SPA-QUIP

Notice To Customers

Controller Functionality Change

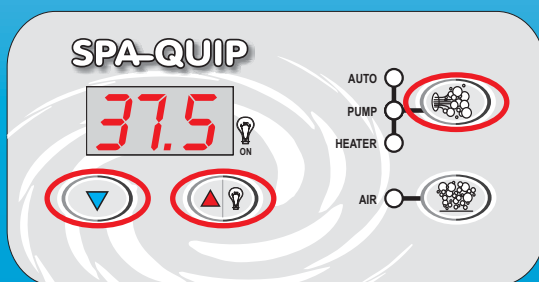
Due to recent changes in electrical safety standards, Spa-Quip controllers now behave differently in the event of a controller error condition. In the past when a controller has entered an error condition it has been possible to reset the controller by turning the power to the controller off then on again.

The controllers are now reset differently, in the event of an error condition the controller can now be reset by pushing a combination of touch pad buttons. The combination of buttons is different depending on the controller model.

Note: Resetting the mains power will not clear an error condition.

Special note: It is important to match your controller user guide to the controller in the spa, the changes to the reset procedure have been up dated to reflect this, but care will have to be taken not to mix up controllers and user guides. Any SP601 controller received with a serial number above SQG106L339703 will be equipped with this reset method.

To reset the SP601 controller from an error condition simultaneously push the three circled buttons.
